STAFF REPORT: 9/13/2023 REGULAR MEETINGPREPAADDRESS: 1815 CHURCHAPPLICATION NO: 2023-8514HISTORIC DISTRICT: CORKTOWNAPPLICANT/OWNER: BENJAMIN NEWMANARCHITECT: ROGER VAN TOLDATE OF STAFF SITE VISIT: 8/31/2023 & 9/6/2023DATE OF PROVISIONALLY COMPLETE APPLICATION: 8/20/2023

SCOPE: ERECT CARRIAGE HOUSE, REPLACE SIDING ON DWELLING

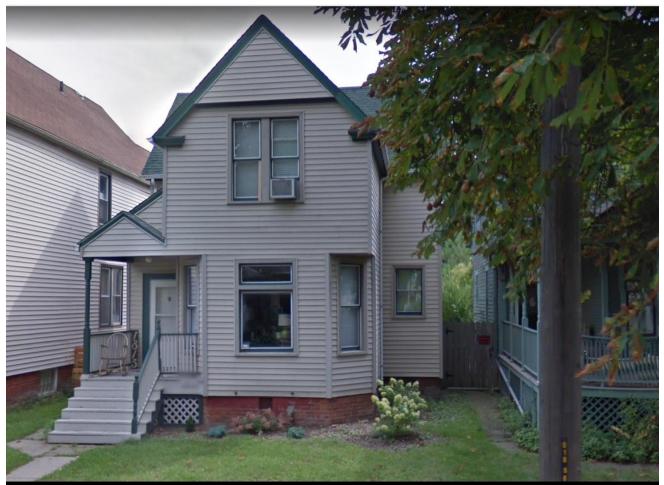
• It is staff's opinion that the new carriage house is compatible in design to the existing historic home while proposed modern materials for the cladding, railing, and windows will mark it as a new building. Although the scale of the building is quite large, it will not be readily visible from the public right of way. Also, a fair amount of the rear yard will remain as open space. Staff recommends the approval of this scope item.
